AGENDA

**PLANNING & ZONING COMMISSION REGULAR MEETING
FRIDAY, SEPTEMBER 20, 2024 - 10:00 AM
MCALLEN DEVELOPMENT CENTER, 311 N. 15TH STREET
EXECUTIVE CONFERENCE ROOM 3**

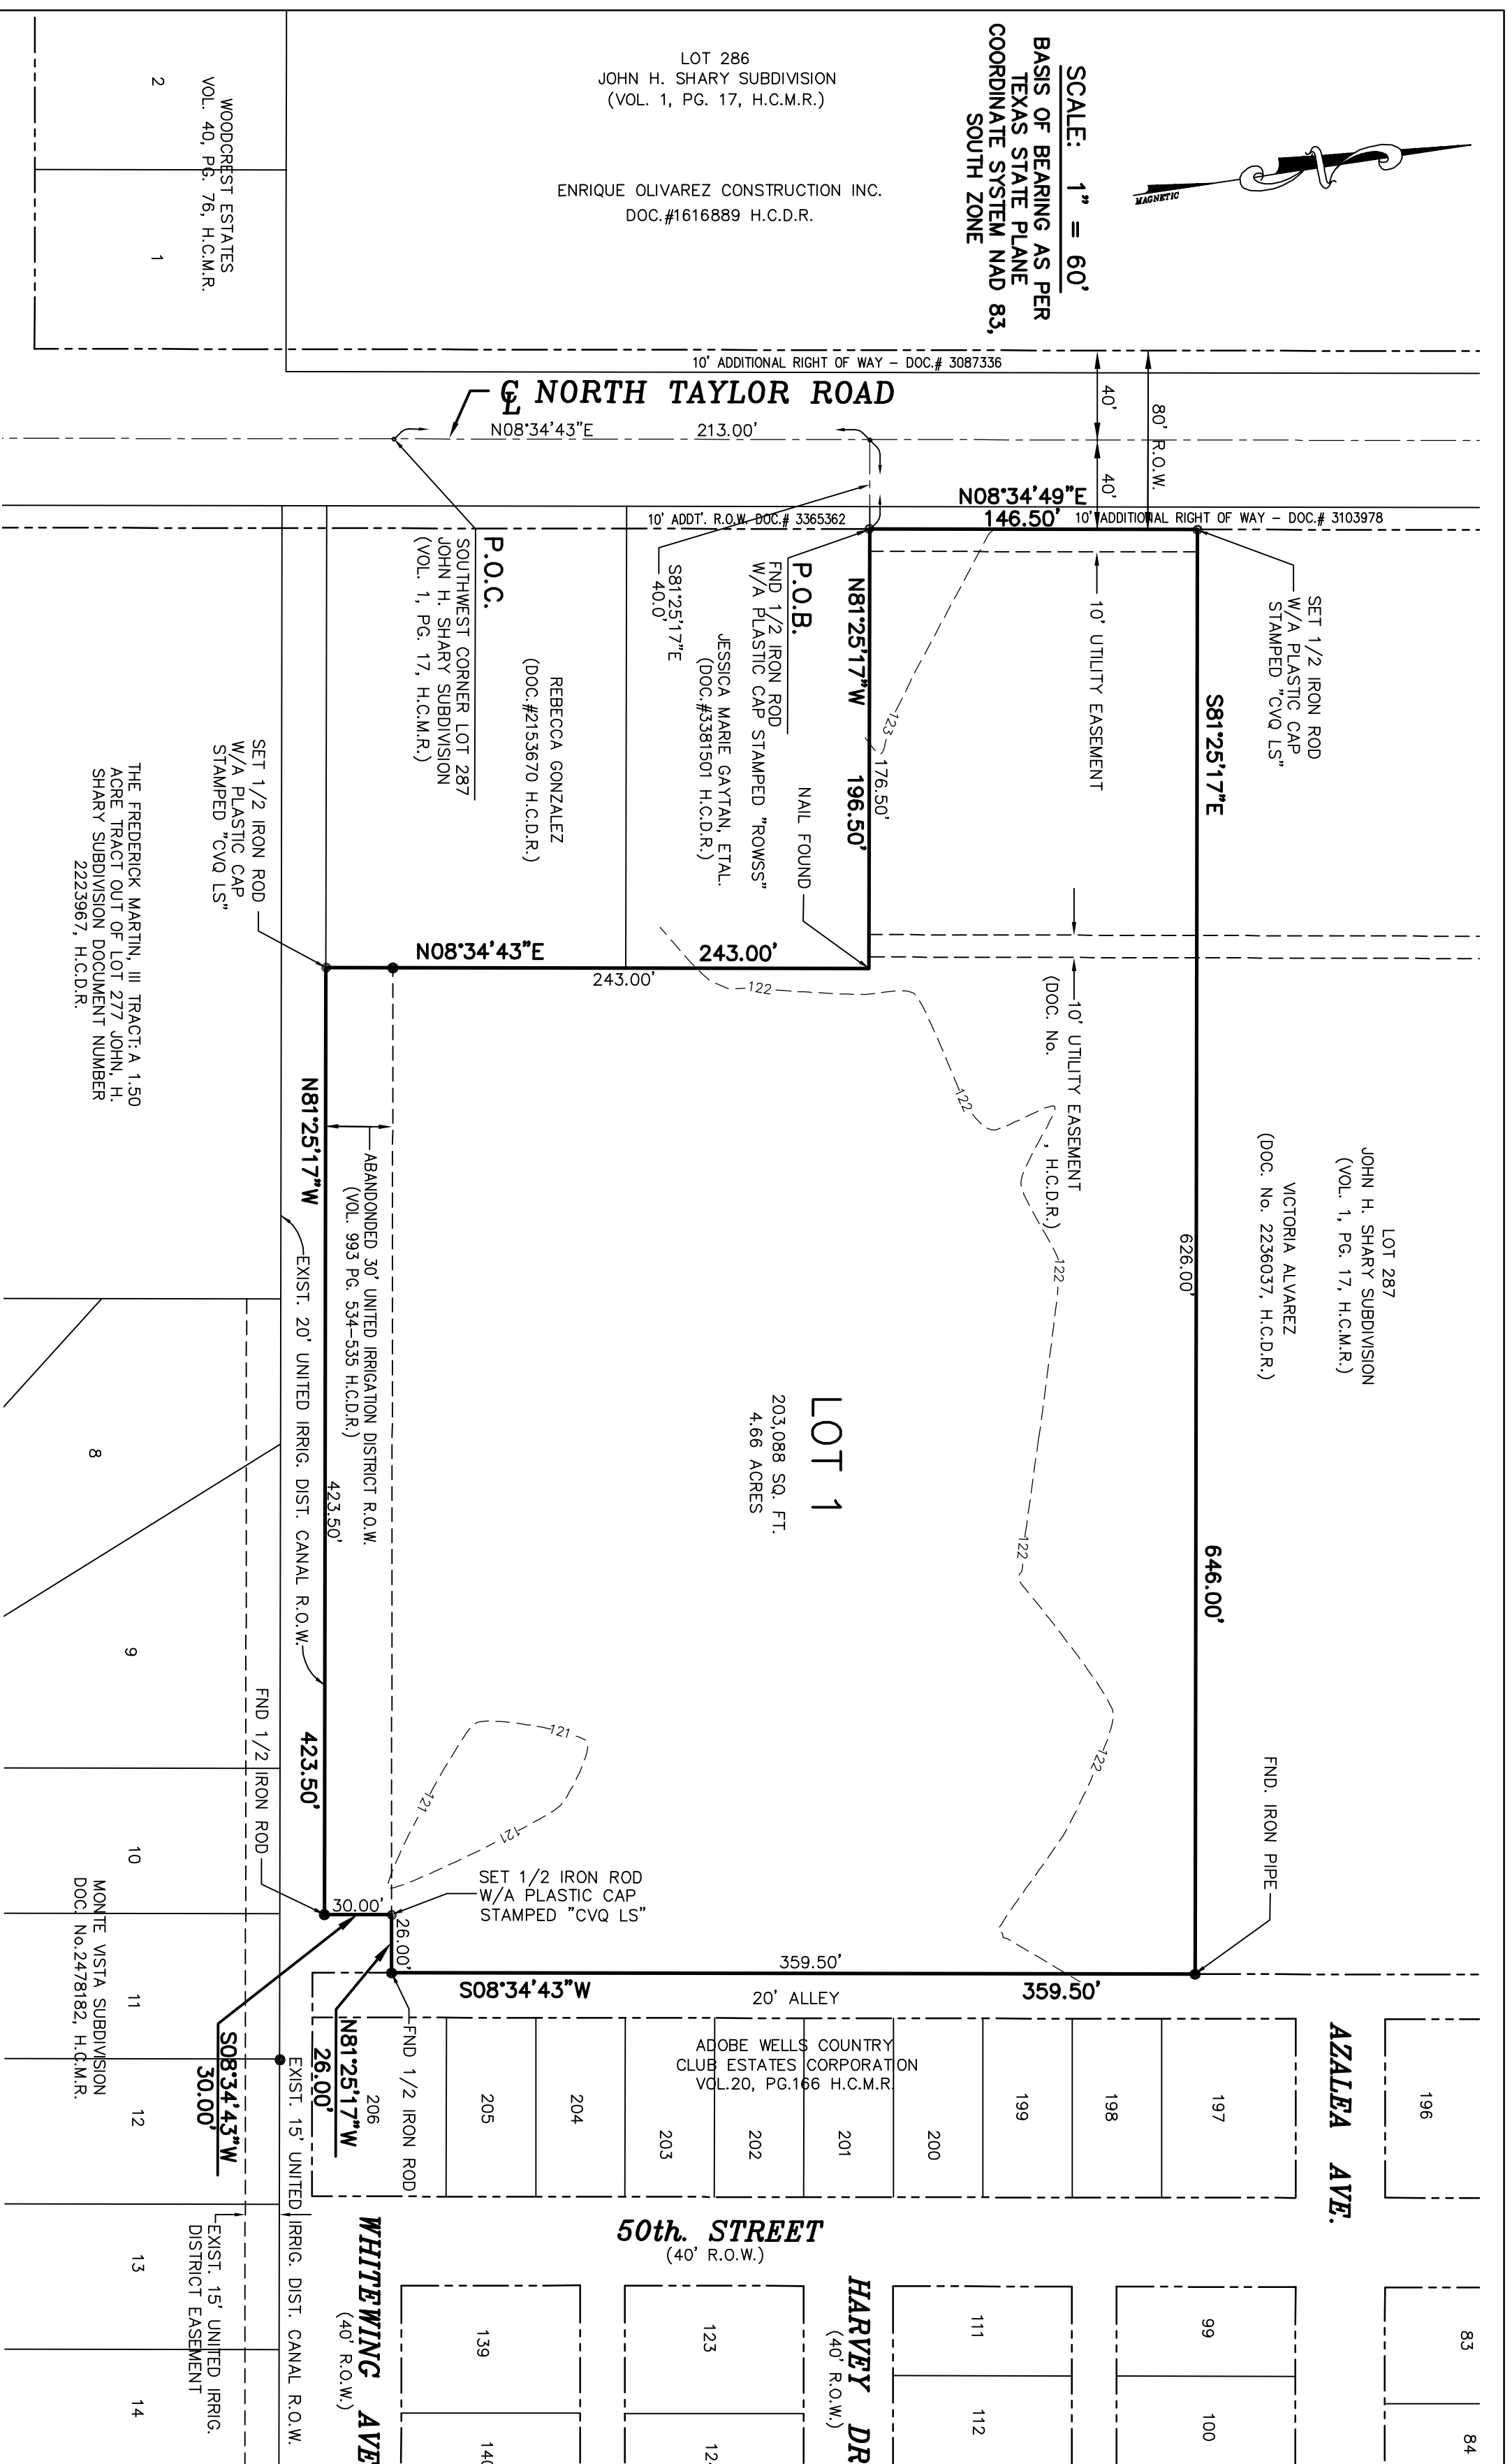
SUBDIVISION NAME: VICTORIA'S OAKS SUBDIVISION	
REQUIREMENTS	
STREETS AND RIGHT-OF-WAYS	
<p>North Taylor Road: 40 ft. of dedication from centerline for 80 ft. total ROW Paving: 52 ft. Curb & gutter: both sides - Based on the plat submitted on July 1, 2024, there is an existing 40 ft. from centerline whereby an additional 10 ft. of ROW dedication was dedicated by separate document #3103978. ***Subdivision Ordinance: Section 134-105 and/or COM Thoroughfare Plan ***Monies must be escrowed if improvements are not constructed prior to recording.</p>	Applied
<p>E/W collector(Southern Boundary,1/4 Mile Location): Dedication as needed for 60 ft. total R.O.W. Paving _40 ft._ Curb & gutter: Both Sides. Pending Items: -Engineer submitted a variance application on December 1st, 2023 in reference to the ROW dedication requirements for the E/W collector(1/4 Mile Collector) along the southern boundary the engineer has indicated that the street would not be able to extend south as there are existing established developments around this subdivision. After review of the area, due to the developed properties to the east and south, the E/W collector street along the southern boundary is not feasible. ***Subdivision Ordinance: Section 134-105 and/or COM Thoroughfare Plan ***Monies must be escrowed if improvements are not constructed prior to recording.</p>	Applied

SETBACKS	
<p>* Front/North Taylor Road: 45 ft. or in line with average setbacks of existing structures or greater for easements, whichever is greater applies. Revisions Needed: -Revise note as shown above, prior to recording. ** Proposing:45 ft. or in line with existing structure , whichever is greater applies. ***Subdivision Ordinance: Section 134-106 ****Zoning Ordinance: Section 138-356</p>	Required
<p>* Rear: Proposing: In accordance with the zoning ordinance, or greater for easement. **Zoning Ordinance: Section 138-356</p>	Applied
<p>* Sides: Proposing: In accordance with the zoning ordinance, or greater for easement. **Zoning Ordinance: Section 138-356</p>	Applied
<p>* Corner: Interior Lot **Current subdivision layout does not propose any buildable lots abutting a street. ***Zoning Ordinance: Section 138-356</p>	Applied
<p>* Garage: 18 ft. except where greater setback is required, greater setback applies. **Zoning Ordinance: Section 138-356</p>	Applied

<p>*ALL SETBACKS ARE SUBJECT TO INCREASE FOR EASEMENTS OR APPROVED SITE PLAN</p>	Applied
SIDEWALKS	
<p>* 4 ft. wide minimum sidewalk required along North Taylor Road. Revisions needed: -Finalize wording for note as applicable, prior to recording. **Proposing: A 4 foot wide sidewalk required on east side of N. Taylor Road. ***Sidewalk requirements may increase to 5 ft. prior to final per Engineering Department requirements, finalize wording for note prior to recording. ****Subdivision Ordinance: Section 134-120</p>	Required
<p>* Perimeter sidewalks must be built or money escrowed if not built at this time.</p>	Required
BUFFERS	
<p>* 6 ft. opaque buffer required from adjacent/between multi-family residential and commercial, and industrial zones/uses. Revisions Needed: -Include note as shown above prior to recording. **Landscaping Ordinance: Section 110-46</p>	Required
<p>* 8 ft. masonry wall required between single family residential and commercial, industrial, or multi-family residential zones/uses. **Landscaping Ordinance: Section 110-46</p>	Applied

<p>*Perimeter buffers must be built at time of Subdivision Improvements.</p>	Required
NOTES	
<p>*Must comply with City Access Management Policy **As per Traffic Department, Only one driveway would be permitted along N. Taylor Road</p>	Applied
<p>* Site plan must be approved by the Planning and Development Departments prior to building permit issuance.</p>	NA
<p>* Common Areas for commercial developments provide for common parking, access, setbacks, landscaping, etc.</p>	NA

NA
	NA
LOT REQUIREMENTS	
<p>* Lots fronting public streets.</p> <p>**Clarify status of remnant tract along southern plat boundary and ensure compliance with minimum lot frontage requirements. As per updated plat submitted on December 11th,2023 area along southern boundary clarified.</p> <p>***Subdivision Ordinance: Section 134-1</p> <p>* Minimum lot width and lot area.</p> <p>**Zoning Ordinance: Section 138-356</p>	Applied
	Compliance
ZONING/CUP	
<p>* Existing: R-1 (Single-Family) Residential Proposed: R-1 (Single-Family) Residential</p> <p>***Zoning Ordinance: Article V</p> <p>* Rezoning Needed Before Final Approval</p> <p>***Zoning Ordinance: Article V</p>	Applied
	NA
PARKS	
<p>* Land dedication in lieu of fee.</p> <p>* Park Fee of \$700 (\$700 X 1 lot/dwelling unit) to be paid prior to recording. Fees are payable prior to recording and can go up or down; as they are dependent on the amount of lots/dwelling units. Must comply with Parkland dedication ordinance requirements prior to recording.</p> <p>* Pending review by the City Manager Office.</p>	NA

COMMENTS	
Comments: -Must comply with City's Access Management Policy. -Any abandonments must be done by separate process, not by plat. -On plat clarify if easements are being dedicated by this plat review and revise as applicable.	Applied
RECOMMENDATION	
Recommendation: STAFF RECOMMENDS APPROVAL OF THE SUBDIVISION IN REVISED FINAL FORM, SUBJECT TO CONDITIONS NOTED.	Applied

MAP
 OF
 TRIPLE "B" MOBILE HOME PARK II
 MALLEEN TEXAS

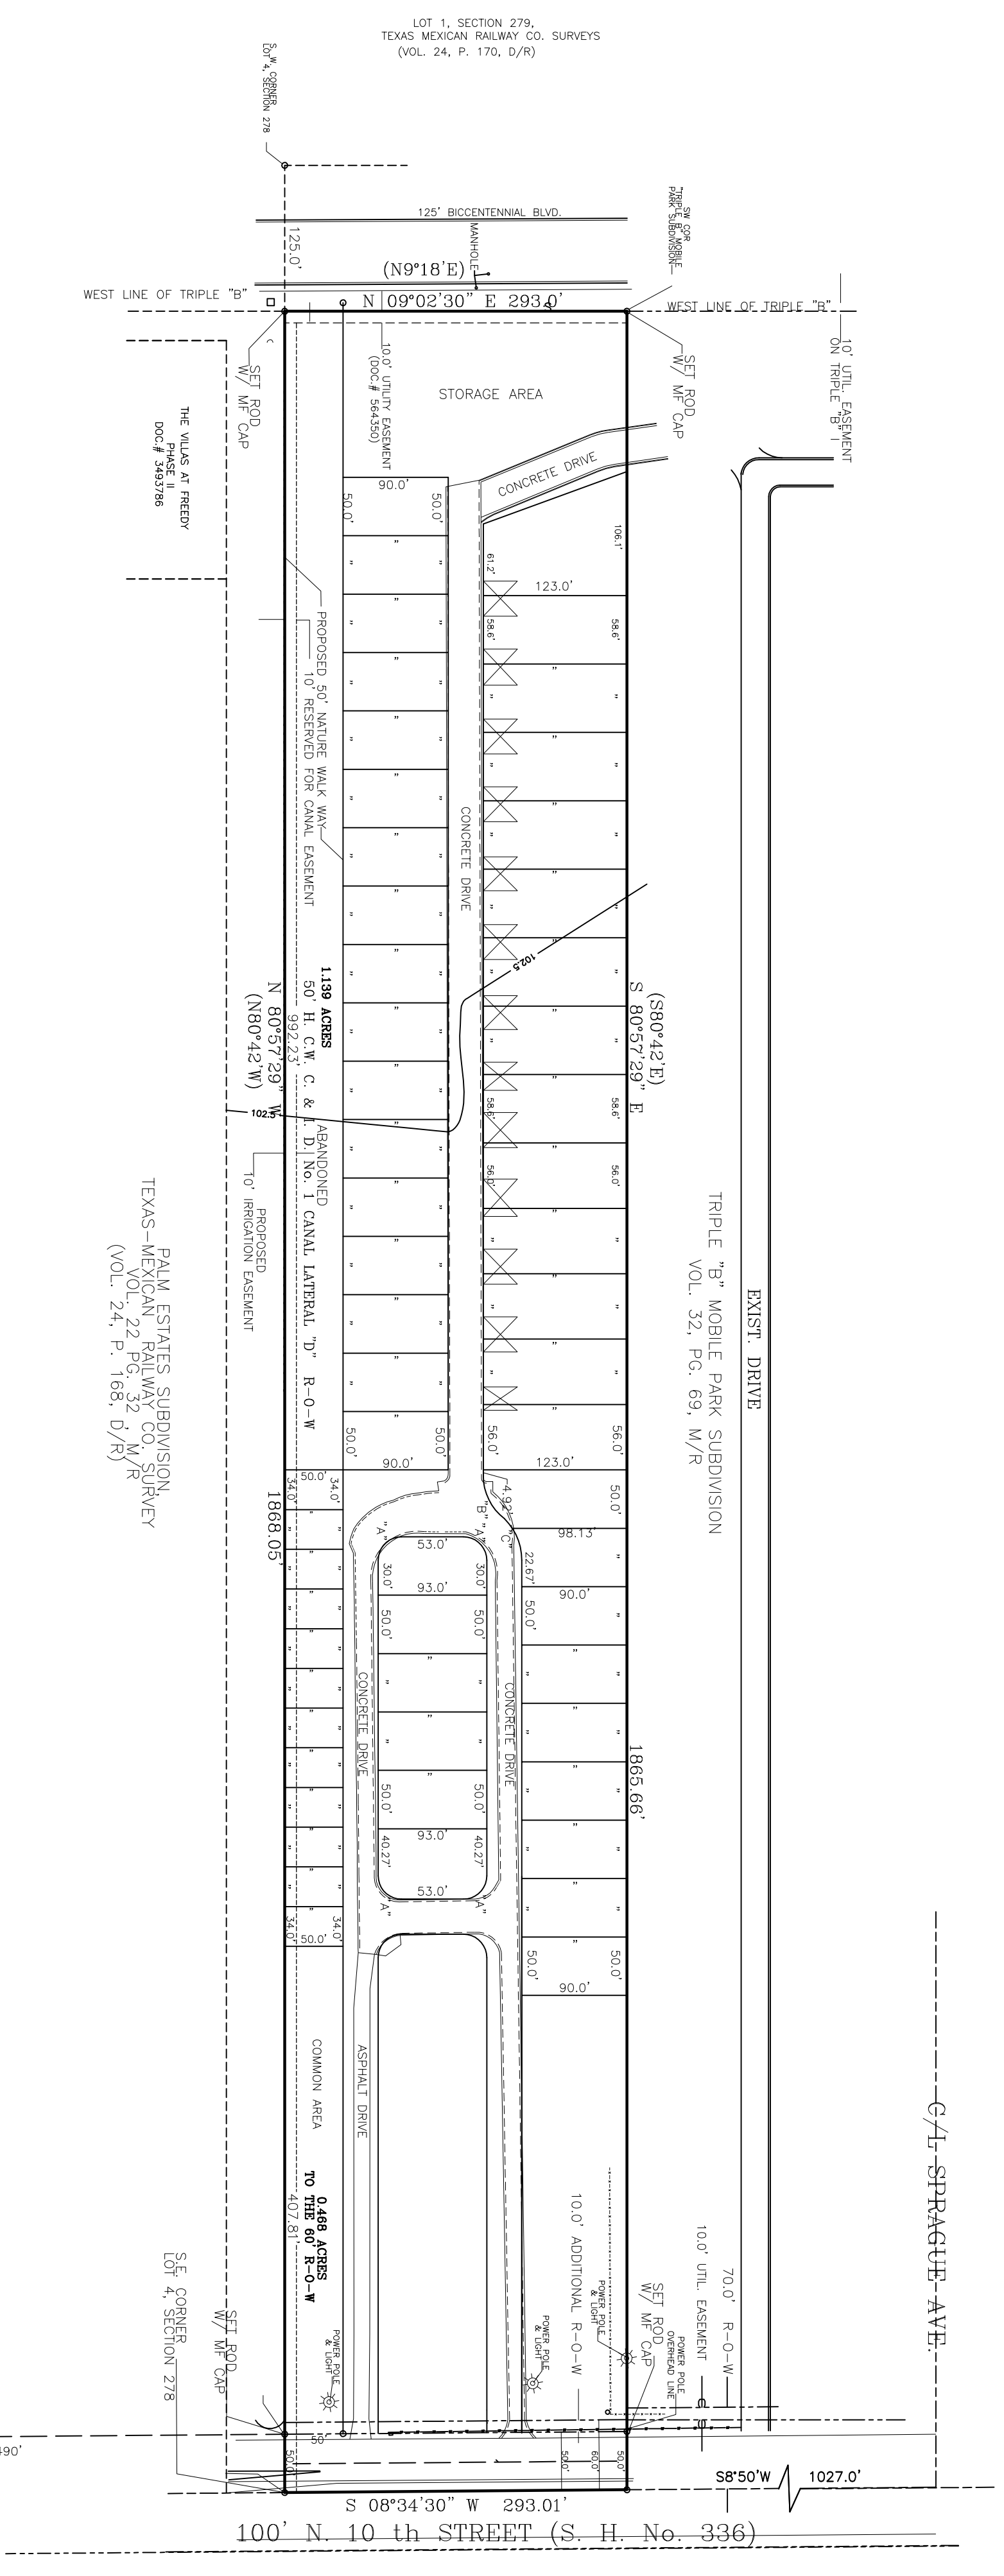
SUBDIVISION NAME: TRIPLE "B" MOBILE PARK II	
REQUIREMENTS	
STREETS AND RIGHT-OF-WAYS	
<p>North 10th Street (S.H. No. 336): Dedication as required for 120 ft. total ROW Paving: by the state Curb & gutter: by the state - Label the centerline, prior to recording. - Label total ROW after accounting for ROW dedication, prior to recording. **Subdivision Ordinance: Section 134-105 **Monies must be escrowed if improvements are required prior to recording **COM Thoroughfare Plan</p>	Required
<p>North Bicentennial Boulevard: Dedication as required for 150 ft. total ROW Paving: 65 ft.- 105 ft. Curb & gutter: both sides - Revise street name as shown above, prior to recording. - Label the centerline, prior to recording. * Developer submitted a variance request on June 14, 2024 in lieu of a full dedication of North Bicentennial Boulevard that an additional 25 ft. be granted as a ROW easement. Plat submitted on July 24, 2024 shows 25 ft. of additional ROW dedication by this plat, Engineering Department is requiring a license agreement that would allow continued use of land until expansion of North Bicentennial Boulevard. License agreement must be finalized prior to recording **Subdivision Ordinance: Section 134-105 **Monies must be escrowed if improvements are required prior to recording **COM Thoroughfare Plan</p>	Required

<p>Interior Drives: 30 ft. driveway Paving: 24 ft. - 30 ft. Curb & gutter: - Internal drives will be private and maintained by the property owner. - Provide details of existing width, prior to final. - Will finalize paving details prior to final but not less than ordinance requirements. * Developer submitted a variance request on June 14, 2024 that the existing driveways and paving remain as is with one entrance and one exit. Staff had no objection to the request as long as drives remained as existing. If modified or any additions made, interior drives must meet minimum requirements. At the Planning and Zoning meeting of August 20, 2024, the variance was approved to maintain existing conditions of the interior drives. **Subdivision Ordinance: Section 134-105 **Manufactured homes and recreational vehicles: Section 122-94 **Monies must be escrowed if improvements are required prior to recording **COM Thoroughfare Plan</p>	Required

SIDEWALKS	
<ul style="list-style-type: none"> * 4 ft. wide minimum sidewalk required on North 10th Street and North Bicentennial Boulevard - Sidewalk requirement may increase to 5 ft. per Engineering Department. Revise plat note #10 as applicable prior to recording. - Proposing: 4 ft. walk required along 10th St. (S.H. #336) **Subdivision Ordinance: Section 134-120 	Required
<ul style="list-style-type: none"> * Perimeter sidewalks must be built or money escrowed if not built at this time. 	Required
BUFFERS	
<ul style="list-style-type: none"> * 6 ft. opaque buffer required from adjacent/between multi-family residential and commercial, and industrial zones/uses and along North Bicentennial Boulevard **Landscaping Ordinance: Section 110-46 	Applied
<ul style="list-style-type: none"> * 8 ft. masonry wall required between single family residential and commercial, industrial, or multi-family residential zones/uses - Provide plat note as shown above, prior to final. **Landscaping Ordinance: Section 110-46 	Required

<ul style="list-style-type: none"> *Perimeter buffers must be built at time of Subdivision Improvements. 	Required
NOTES	
<ul style="list-style-type: none"> * No curb cut, access, or lot frontage permitted along North Bicentennial Boulevard **Must comply with City Access Management Policy 	Applied
<ul style="list-style-type: none"> * Site plan must be approved by the Planning and Development Departments prior to building permit issuance. - Plat notes will be required once site plan is finalized regarding maximum number of spaces, minimum space area, not for sale, etc. 	Required
<ul style="list-style-type: none"> * Common Areas, any private drives, etc. must be maintained by the lot owners and not the City of McAllen. - Revise plat note as shown above, prior to recording. 	Required
<ul style="list-style-type: none"> * Common Areas for commercial developments provide for common parking, access, setbacks, landscaping, etc. 	Applied

<ul style="list-style-type: none"> * Minimum lot width and lot area - Plat note will be established once site plan is finalized. **Zoning Ordinance: Section 138-356 **Manufactured homes and recreational vehicles: Section 122-93 	<p>Applied</p>
ZONING/CUP	
<ul style="list-style-type: none"> * Existing: R-4 & C-3 Proposed: R-4 & C-3 - Engineer must verify if proposed subdivision is within appropriate zoning as it may prompt changes to plat and or rezoning process, review and finalize prior to recording. ***Zoning Ordinance: Article V 	<p>Required</p>
<ul style="list-style-type: none"> * Rezoning Needed Before Final Approval - Engineer must verify if proposed subdivision is within appropriate zoning as it may prompt changes to plat and or rezoning process, review and finalize prior to recording. ***Zoning Ordinance: Article V 	<p>Required</p>
PARKS	
<ul style="list-style-type: none"> * Land dedication in lieu of fee. A park fee of \$700 per dwelling unit must be paid prior to recording. Engineer submitted a variance to land dedication on June 06, 2024, and clarified total amount of spaces to be 59 with 3 remaining vacant spaces. They also proposed a nature walk on the south side of the park to be considered in lieu of the \$700 per space park fee. The request will be reviewed by the City Manager's Office and if approved, \$700 per dwelling unit must be paid prior to recording. The request was approved with the condition that only the 3 remaining vacant spaces would pay for park fees (3 x \$700 = \$2,100). 	<p>Required</p>

COMMENTS	
<p>Comments:</p> <ul style="list-style-type: none">- Any abandonments must be done by separate process, not by plat, prior to recording.- Internal drives will be private and maintained by the property owner.- Each mobile home space shall have a minimum 1500 sq. ft. and each RV space must be in compliance with city ordinances.- No portion of the subdivision may be sold, transferred, or conveyed unless a subdivision is made & filed for record.- Maximum number of spaces for mobile homes and RVs will be established once site plan is finalized.- Carports, structures, and/or additions to mobile homes or recreational vehicles must meet setbacks as noted.- Additional requirements/notes as needed before recording.- As per engineer plat states 59 maximum number of lease spaces, but the site plan only shows 58 spaces for lease.- Plat submitted on July 24, 2024 shows 25 ft. of additional ROW dedication by this plat, Engineering Department is requiring a license agreement that would allow continued use of land until expansion of North Bicentennial Boulevard. License agreement must be finalized prior to recording <p>*Must comply with City's Access Management Policy.</p>	Applied
